**From:** Scala, Mary Joy  
**Sent:** Thursday, October 23, 2014 3:58 PM  
**To:** Gathright, Clark (cgathright@dgarchs.com)  
**Subject:** BAR Action 418 17th St NW Oct 21, 2014

**RE: Certificate of Appropriateness Application**  
BAR 13-10-01  
418 17th Street NW  
Tax Parcel 090008000  
Beta Bridge LLC, Owner/ Daggett & Grigg Architects, Applicant  
Pergola Design

**CITY OF CHARLOTTESVILLE  
BOARD OF ARCHITECTURAL REVIEW  
STAFF REPORT  
October 21, 2014**

Pergola Design

Entry Portal Elevation

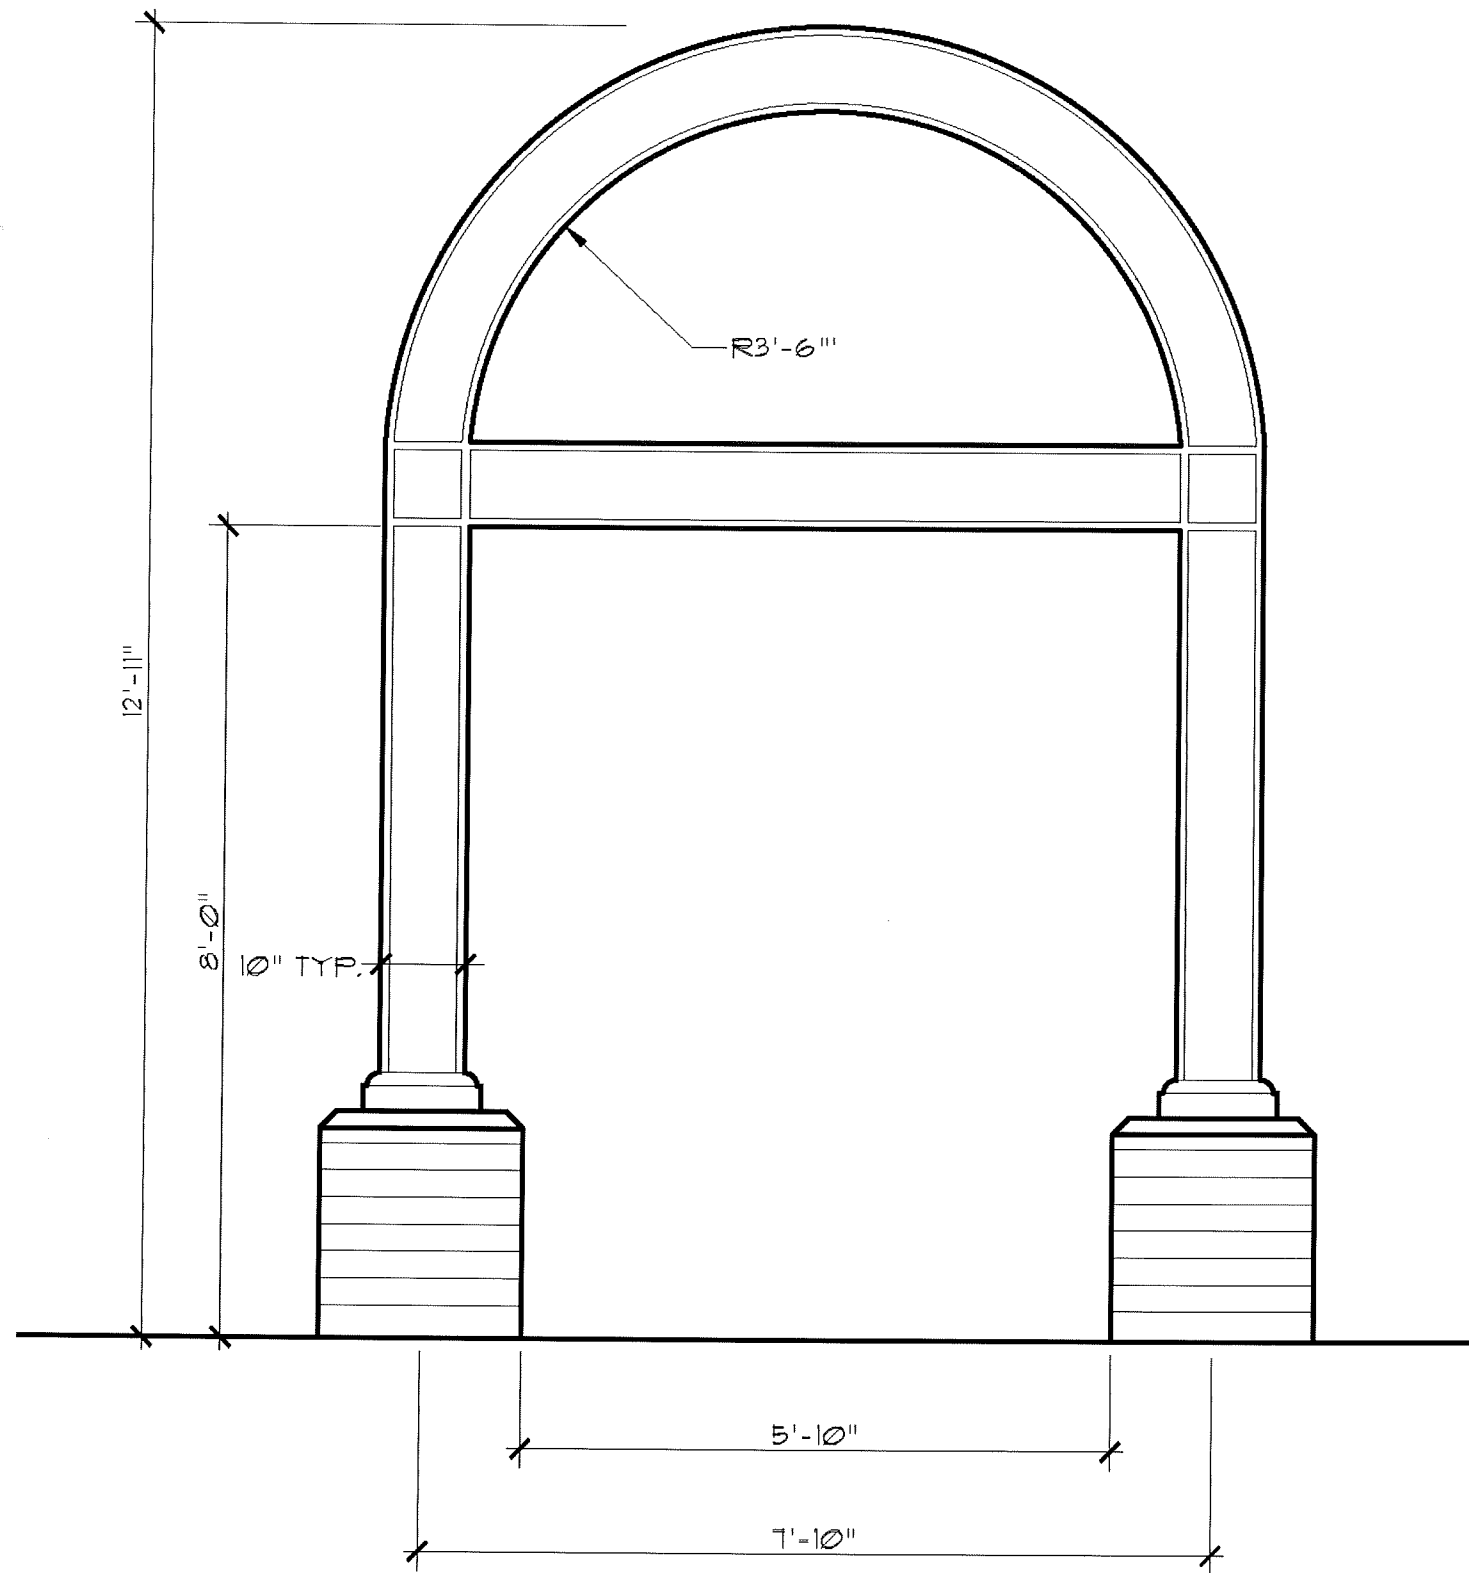
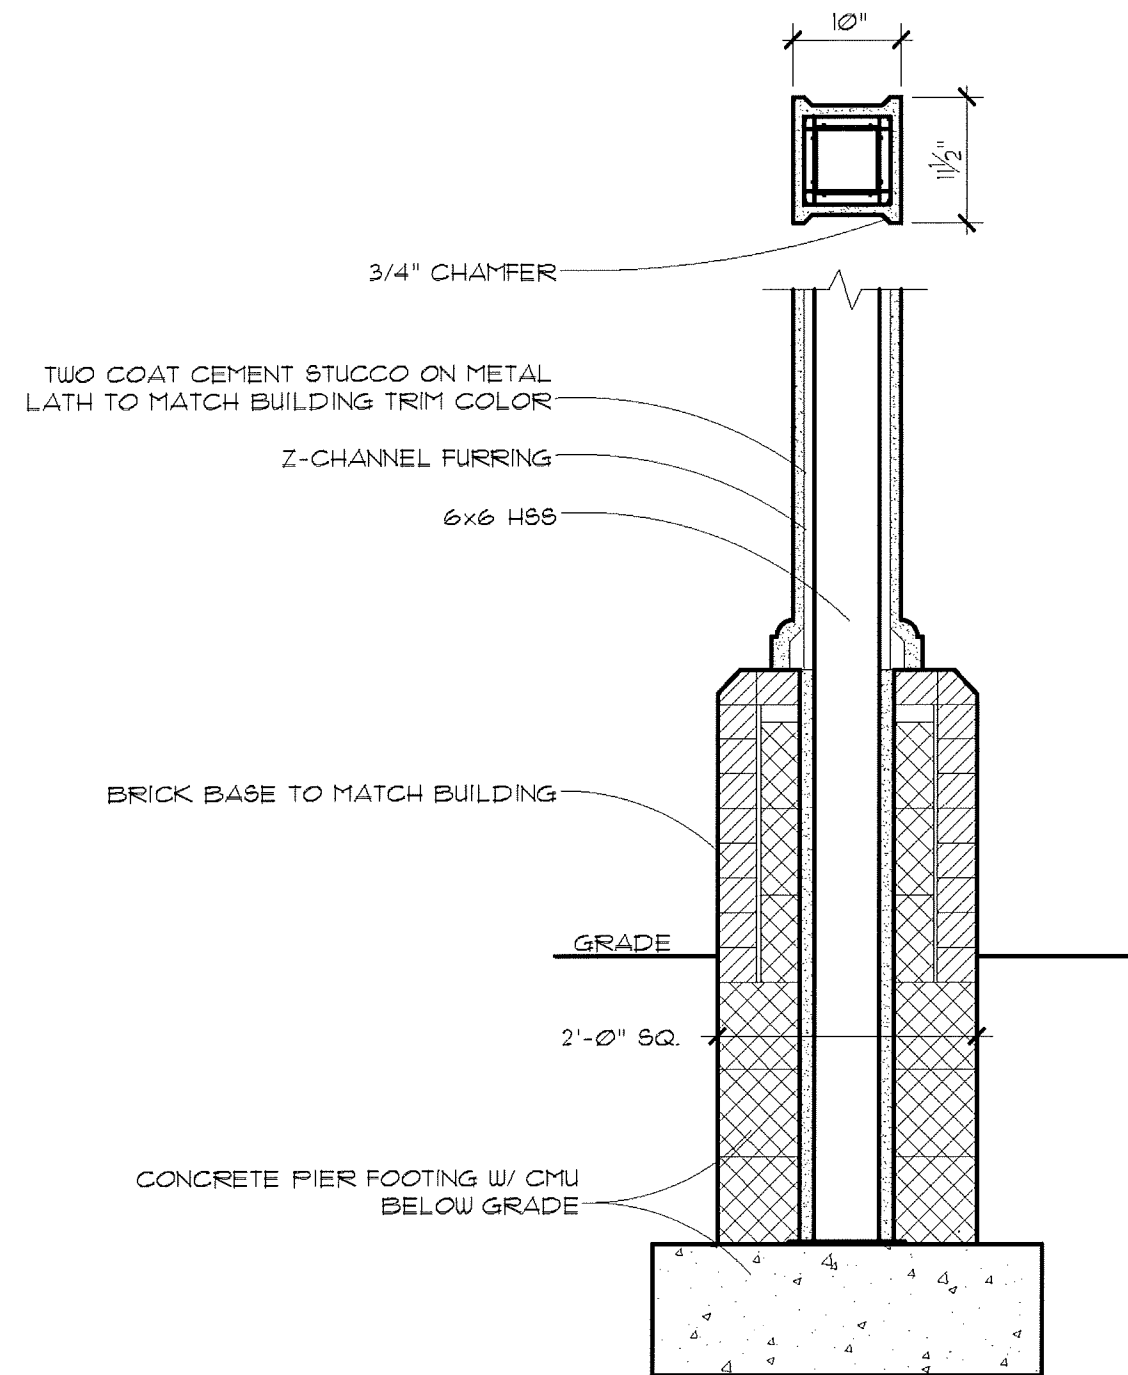
**BAR suggestions included: A re-worked design should be in scale with the smaller residential building; painted wood or steel; or could avoid overhead structure entirely, instead using low brick piers or use plantings to mark the entrance.**

The applicant was asked to come back to the BAR with a revised design for the entrance structure (previously shown as a pergola). The proposed design is tube steel with stucco exterior to match the stucco trim color on the existing building and the new addition (dark beige - see p.8 of submittal), and brick base to match existing brick. The shape mimics the existing apartment building's arched stairwell entry. The entrance structure aligns with the front wall of the existing apartment building. [NOTE: the "new ornamental metal railing" shown on p. 2 of submittal is not attached to the entrance structure - it is located 12 feet back at a window well.]
